City of Portland, Maine - Building or Use Permit Application
 389 Congress Street, 04101 Tel: (207) 874-8703, Fax: (207) 874-8716

PERMIT ISSUED	
Permit No: 01-0574UN	Issue Date: 5 2001
CBL: 062 E002001

Proposed Project Description: Replace existing 9' 6" X 8' 3" Porch	FIRE DEPT: <input checked="" type="checkbox"/> Approved <input type="checkbox"/> Denied	INSPECTION: Use Group: A-2 Type: 5B
--	--	---

BUILDING PERMIT REPORT

Application for Exemption From Building Code Railing Height Requirements

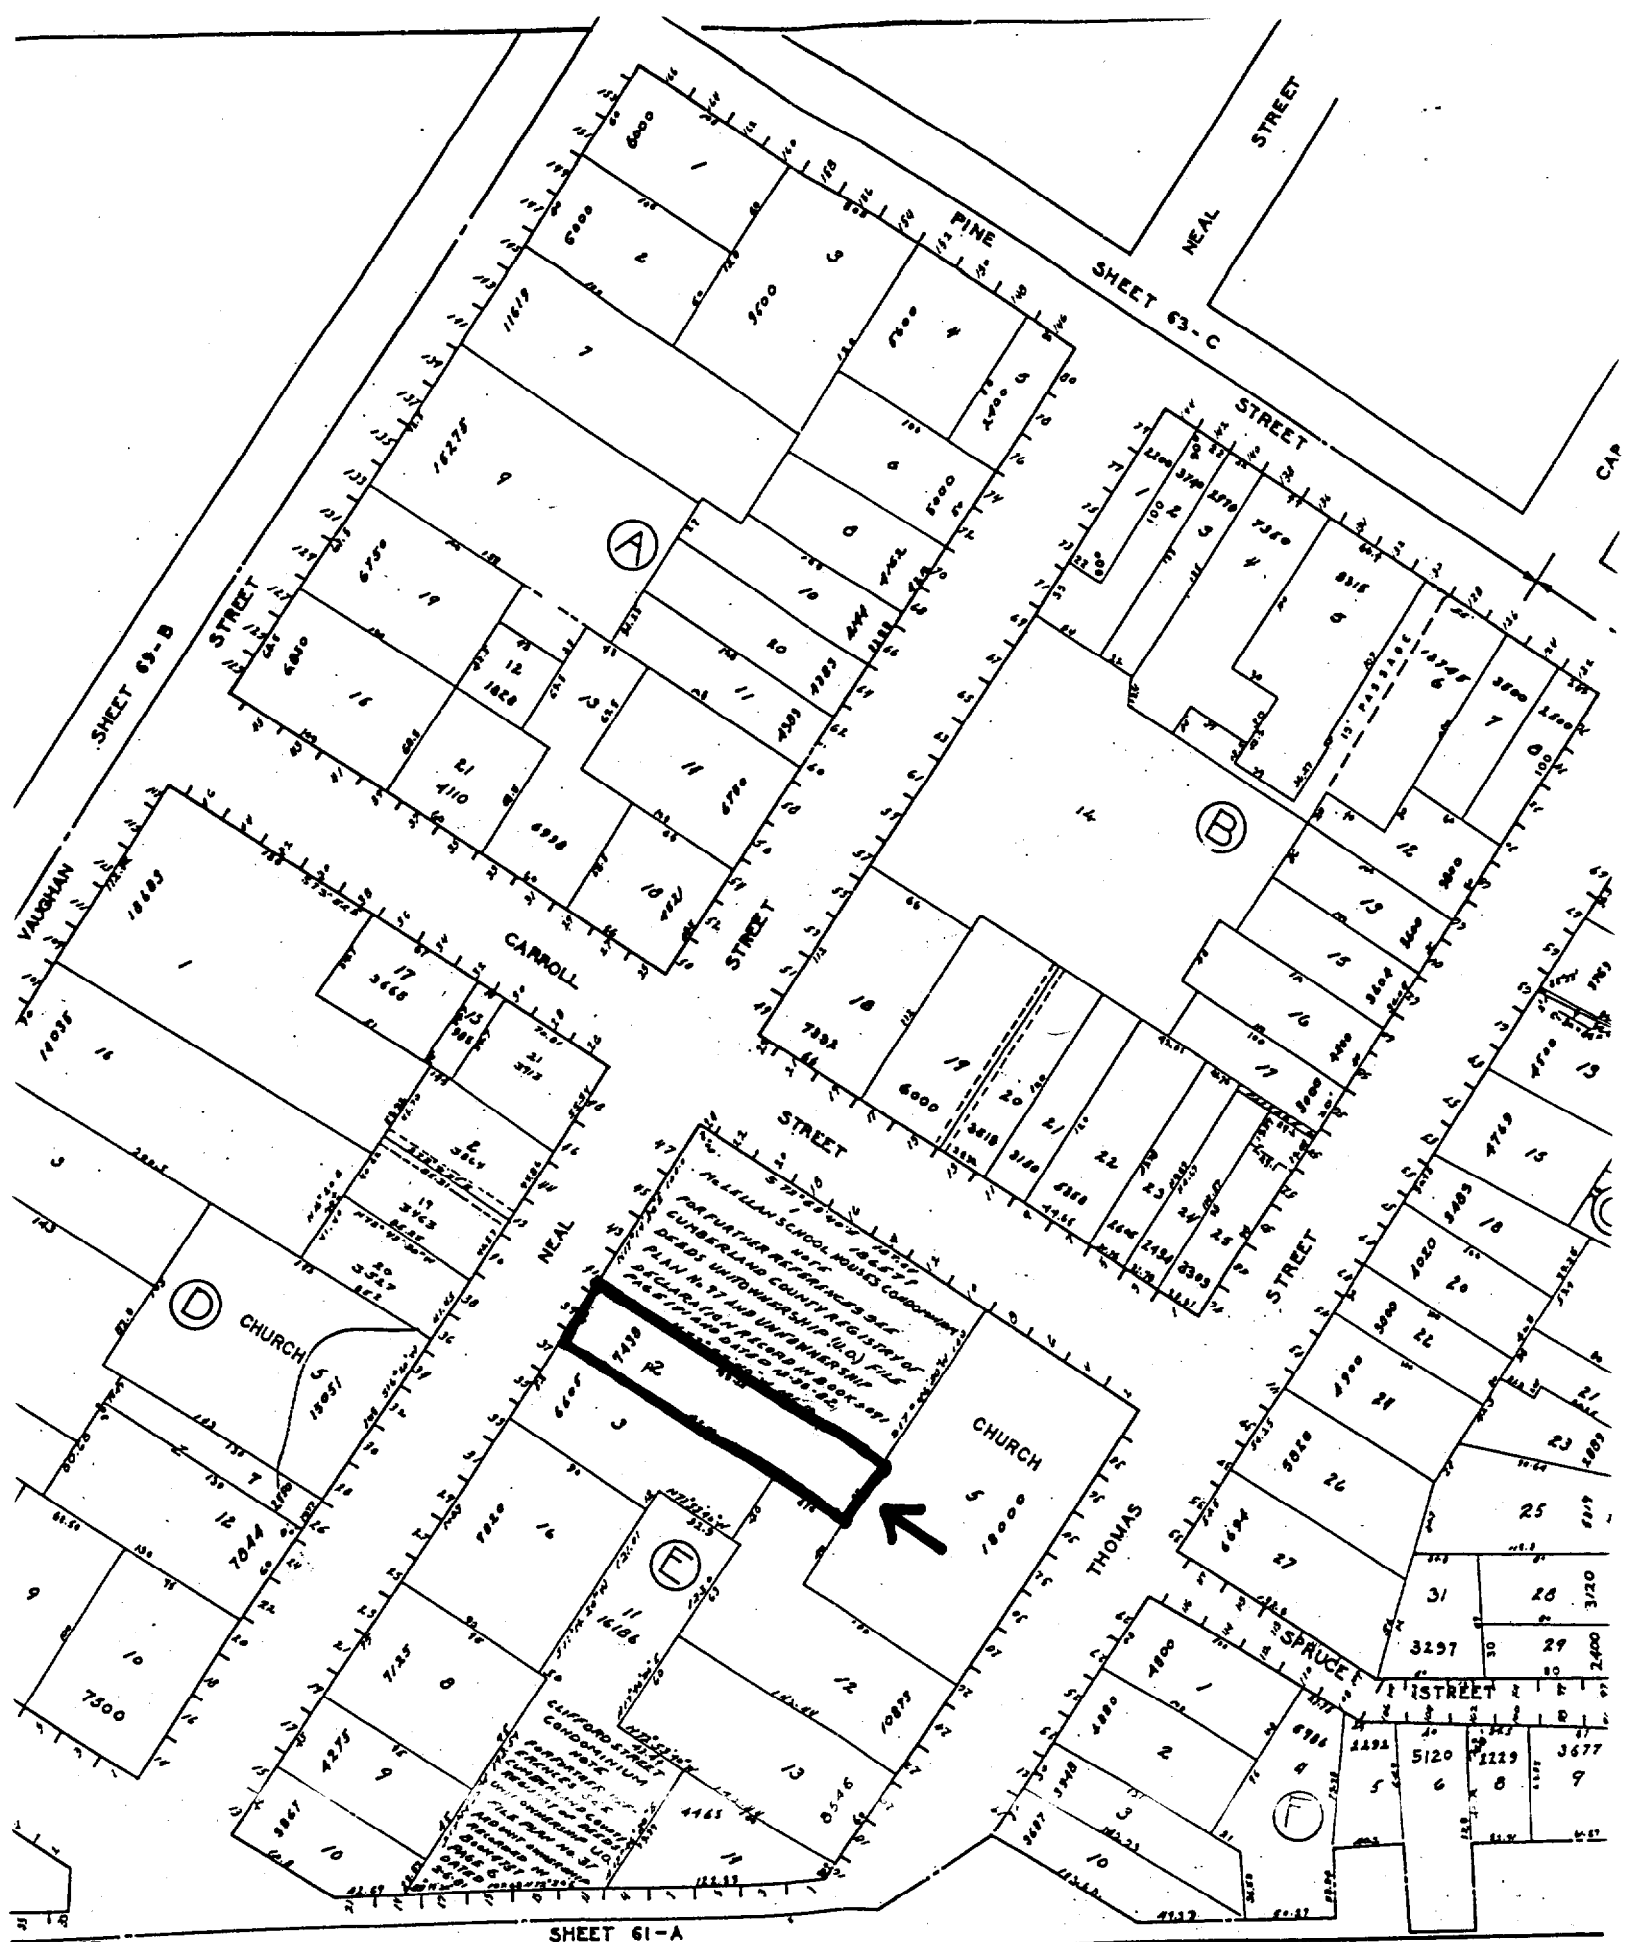
1. Current Use of Property (If multi-family residence, please indicate # of units):
~~Single Family~~ ACTUAL # A 3 FAMILIES (a)
2. Proposed Use, if applicable: _____
3. The distance from the porch deck to the ground: 1st floor 34", 2nd floor 12'8"
4. The number of existing stair risers: 5
5. The current railing height and/or documented original railing height: 31"
6. The railing height requested: 36"

Historic Preservation Committee/Staff Recommendation: STAFF RECOMMENDS 36" - THIS HEIGHT WILL MAINTAIN HISTORIC PROPORTIONS / SCALE OF PORCH. W/TH

Inspections Staff Recommendation: ~~THIS WILL COMPLY W/ THE TALE CODE IN SEVERAL WEEKS~~ PER SECTION 3406. (a)

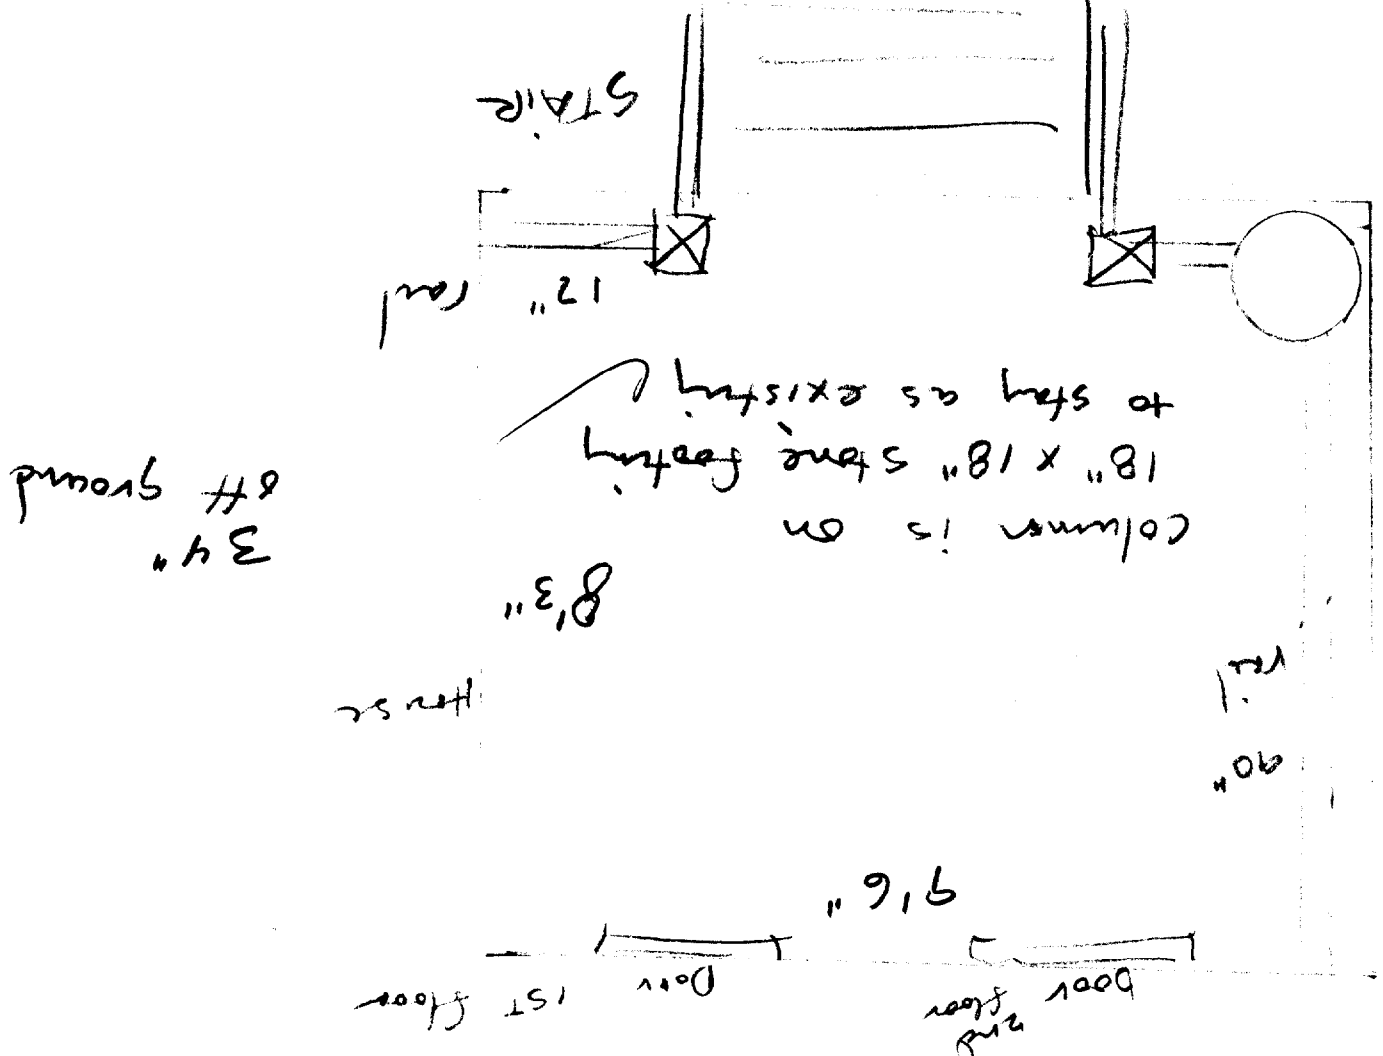
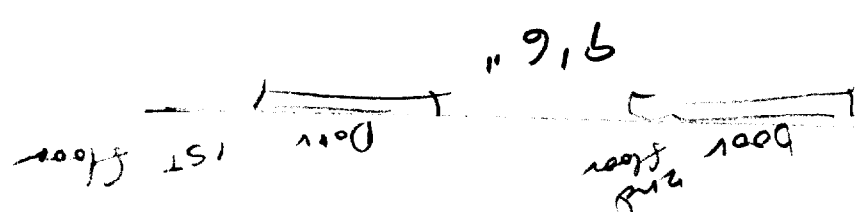
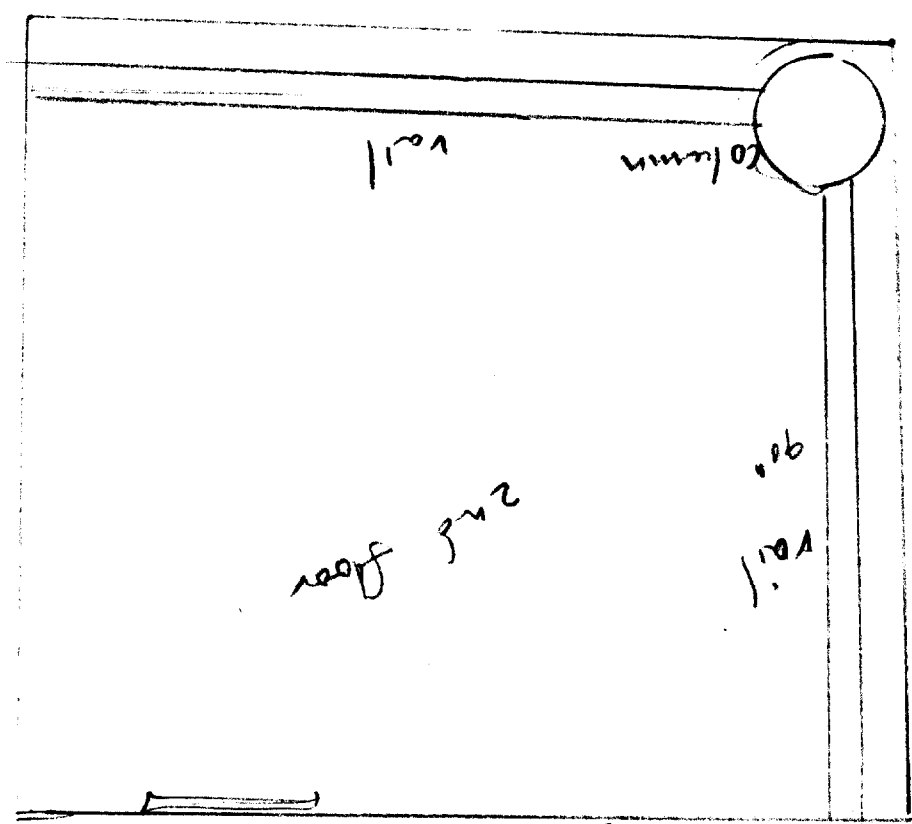
34" off ground

Column is on 18" x 18" stone footing to stay as existing

8'3"

2nd floor deck is 12'8" off ground
